# Fox Canyon Groundwater Management Agency

Summary of Comments on the GSP Evaluations for the Oxnard, Pleasant Valley, and Las Posas Valley Basins

OCTOBER 2024

## Groundwater Elevations Measured in the Fox Canyon Aquifer (Spring 2015)

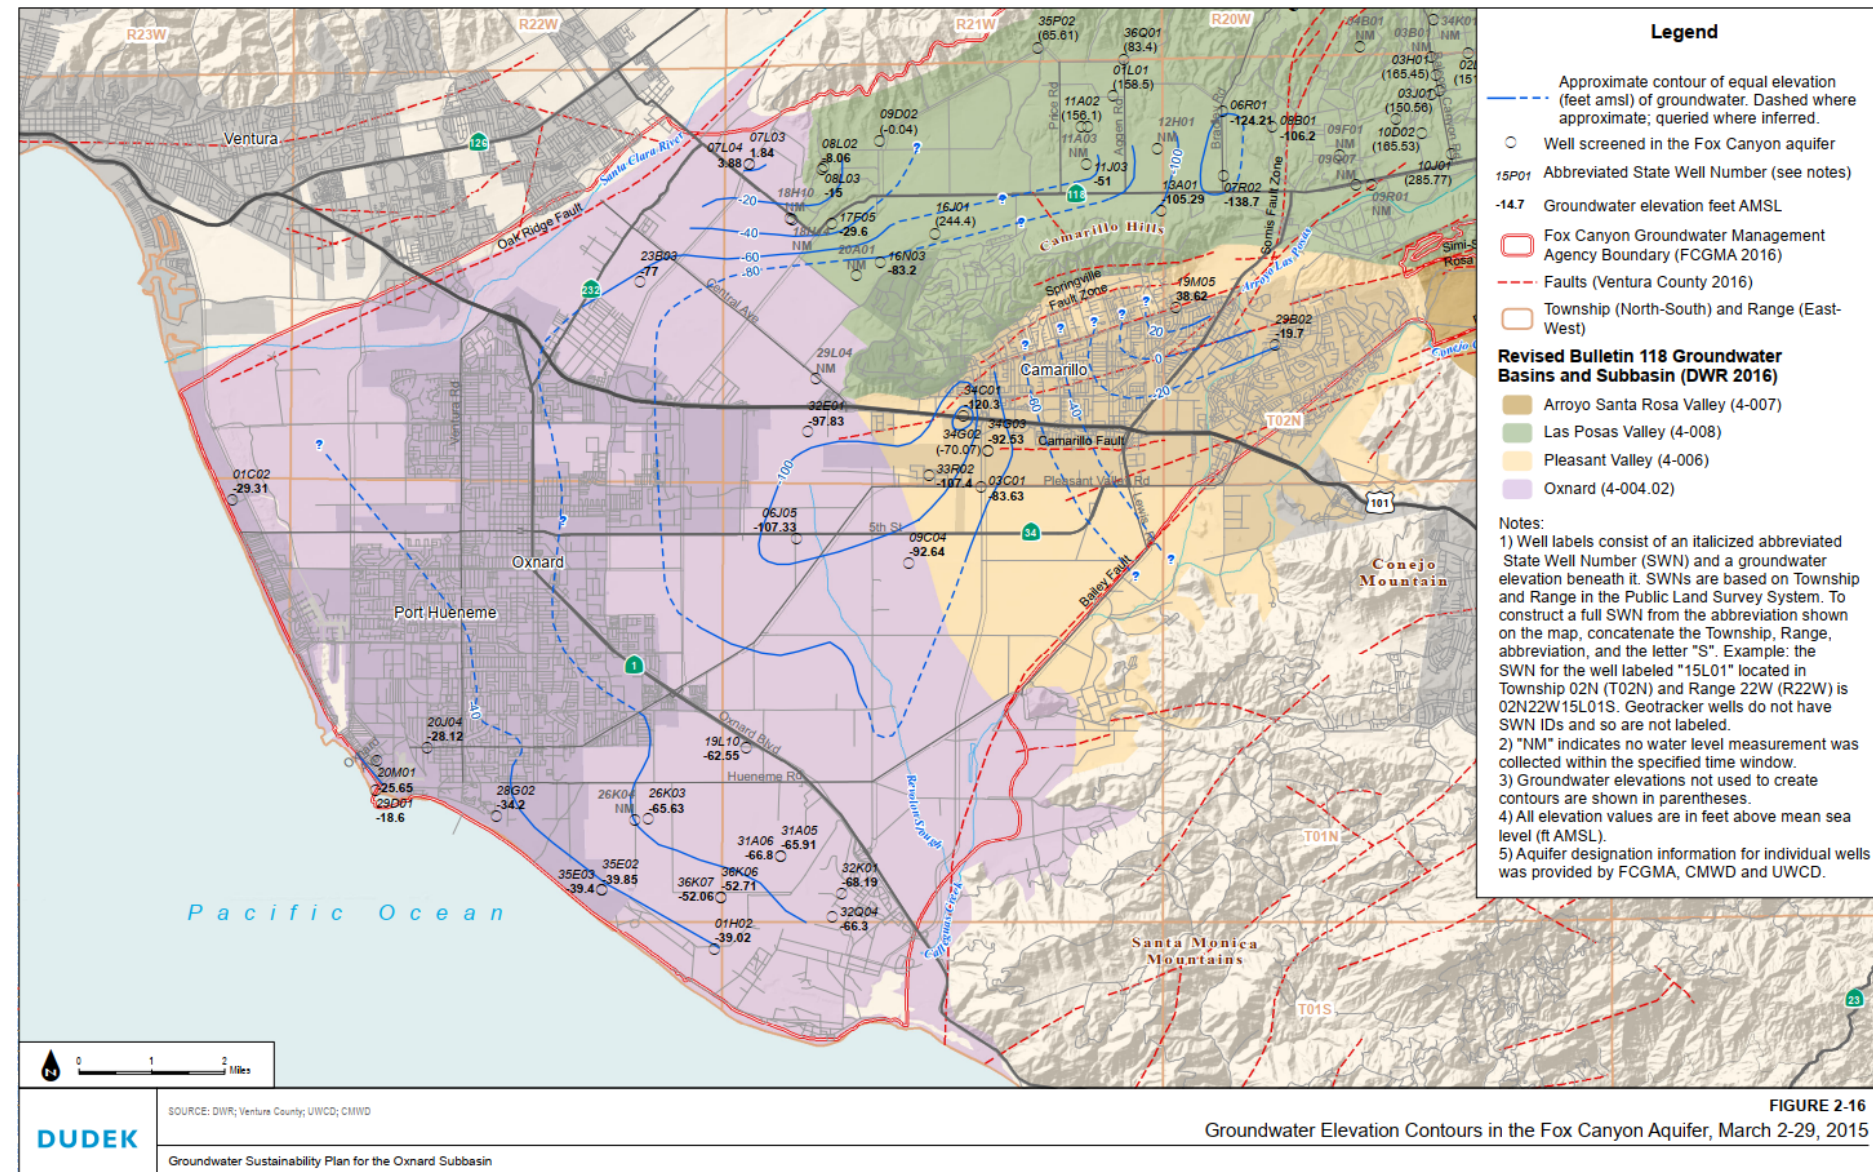
- Groundwater production in the PVB does not contribute to seawater intrusion in Oxnard

- There is no physical boundary or geologic difference in the LAS between basins
- Historical groundwater elevations indicate that the pumping trough spans the boundary between Oxnard and PV
